R E M A R K S

Amendments to the Drawings:

FIG. 1

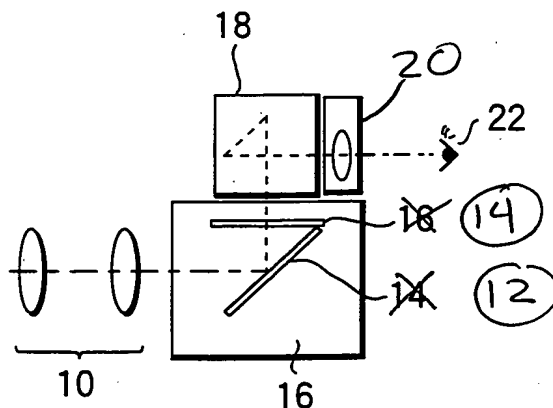
Fig. 1 has been amended as set forth hereinabove to correct the informalities pointed out by the Examiner.

Fig. 1 has been amended to change the first occurrence of reference numeral 16 to 14, to correctly designate the screen mat, in accordance with the description in the specification at page 7, line 19. In addition, Fig. 1 has been amended to change reference numeral 14 to 12, to correctly designate the mirror, in accordance with the description in the specification at page 7, line 18. Still further, Fig. 1 has been amended to add reference numeral 20 to designate the eyepiece optical system 20, in accordance with the description in the specification at page 7, line 20.
